DESIGN STATEMENT and RESPONSE to MSDC Pre-Application Email dated 6th January 2026:

3 Turners Mill Close
HAYWARDS HEATH
RH16 1NL

Ground Floor Extension and
Loft Conversion/Extension.

PROPOSED : Elevations Comparison

ReDesign 2 2026 : ELEVATIONS Proposed for Pre-Application dated 30JAN26:-

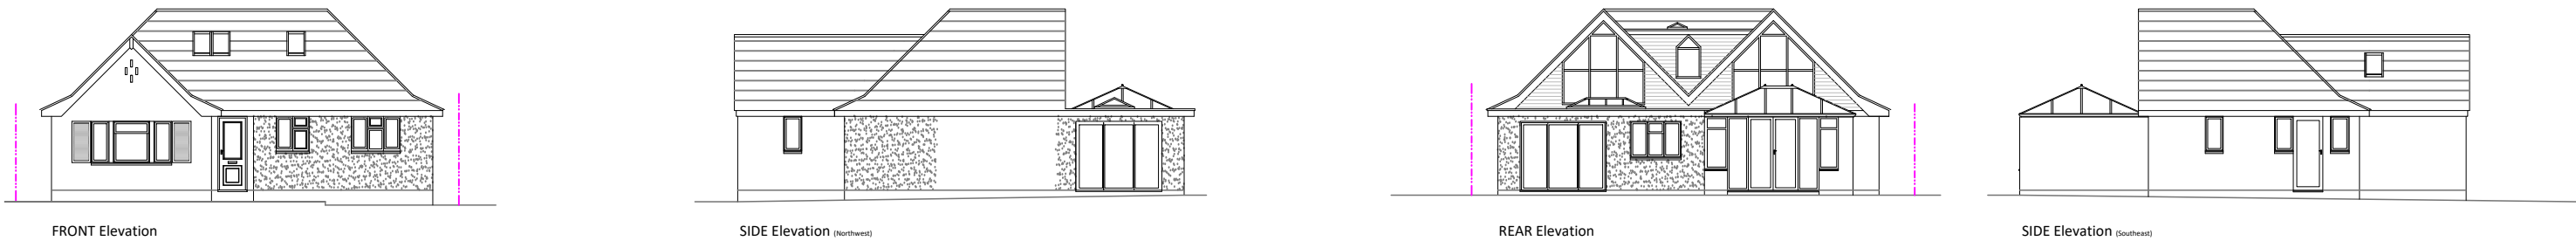
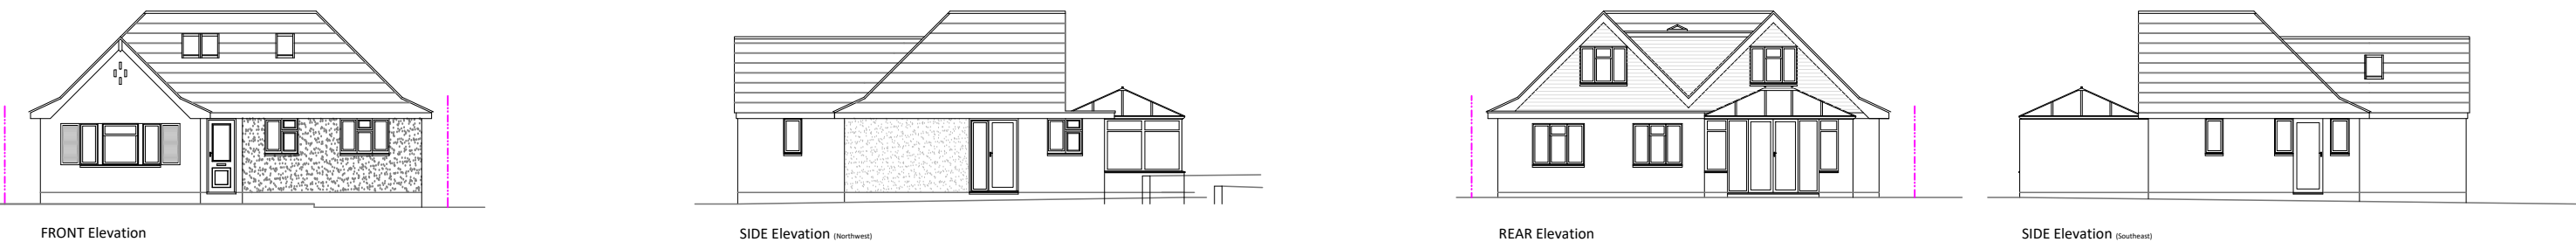
In response to :
"The proposed rear dormer is considered to be of a large flat roof design, which is out scale with the original dwelling".

"In addition, the proposed glazing pattern appears cluttered and, due to a large amount of glazing at first floor level, creates a greater sense of overlooking."

Impact on neighbouring amenities
Policy DP26 of the MSDP requires development not cause significant harm to the amenities of existing nearby residents and future occupants of new dwellings, including taking account of the impact on privacy, outlook, daylight and sunlight, and noise, air and light pollution.
As set out above, it is noted that the proposal includes significantly more glazing on the rear elevation at first floor level than the existing arrangement which creates a greater sense of overlooking and can lead to direct views into the neighbouring property's private amenity space.

The design of the gables as an 'extension' not as 'dormers' and reflects the examples noted closely follows the principles demonstrated in MSDP 'Roof Design', page 99 : Figure 6C using a proportionate 'hipped' roof design to successfully soften the elevational views, with the ridge height being maintained uniformly in line with point MSDP 6.3.10, and generally DG38's requirements noted in the introduction section.

Additionally the flat area roof equals less than 8% of the whole roof area and therefore is not proportionately large and nor out of scale to the roof as a whole.

The rear elevation design is:
- Balanced proportionally with the gable i.e. in 'thirds' in line with MSDG 6.3.5,
- Below the ridgeline as per 6.3.7,
- The face wall line is set into the rear elevation thus is integral to the roof as per example on MSDG page 98 - top right picture, to work harmoniously and compliment the overall roof form.

Accepted, and note the preceding design has been heavily amended to further meet MSDG 6.3.1 and 6.3.2 with the reduction of the number of windows, the total glazed area and height of the windows, plus a more 'contemporary' design to compliment the existing fenestration and facade. Also note that the original design was intended to particularly to meet MSDG 6.3.2 points 1 and 2 :

Accepted, and note the preceding design has been heavily amended to reduce the impact on privacy by reducing the number of windows and the individual window area. We note that any future development in the college field opposite will also be required to afford the residents on No. Turners Mill the same privacy and meet with Policy DP26.
